UNITED STATES PATENT AND TRADEMARK OFFICE

Office Action Summary

10/727,306

WILSON, DOUGLAS B.

FIG. 6

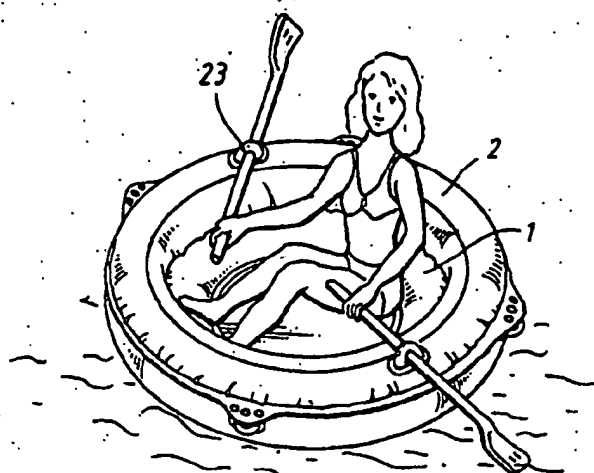
Regarding claim 12, each first section (Att.) is capable of being detached from the vehicular control means 2 as seen in Fig. 6.

FIG. 7

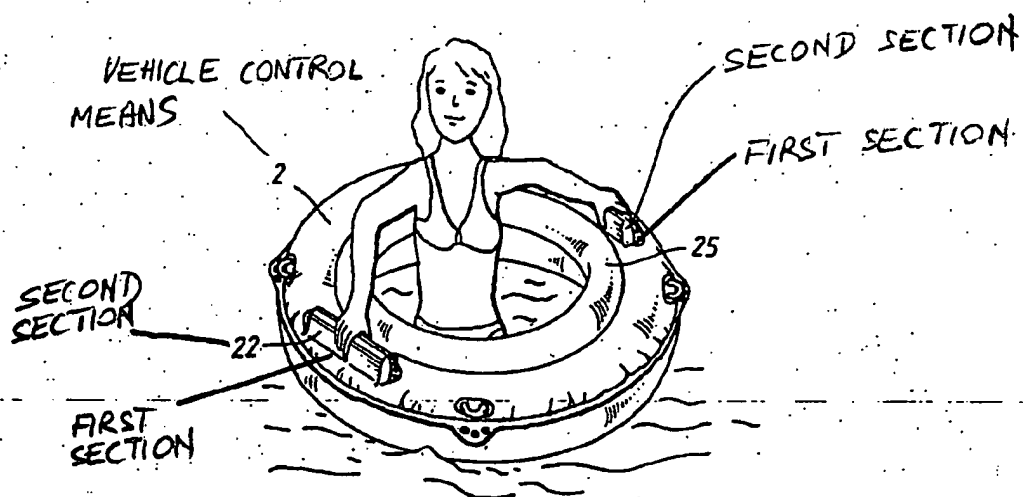
a first section (unnumbered. See Attachment) that connects to a predetermined portion of the vehicular control means 2; and

a *flexible* section 22 that connects to the first section (Att.) that is capable of supporting at least a portion of a vehicular operator's body (Fig. 7).

Regarding claim 3, the portion of the body supported by the second section includes at least a forearm, wrist, or hand (Fig. 7).

Regarding claim 5, the second section 22 includes at least two second sections 22 (Fig. 7) that each connect to the first section (Att.).
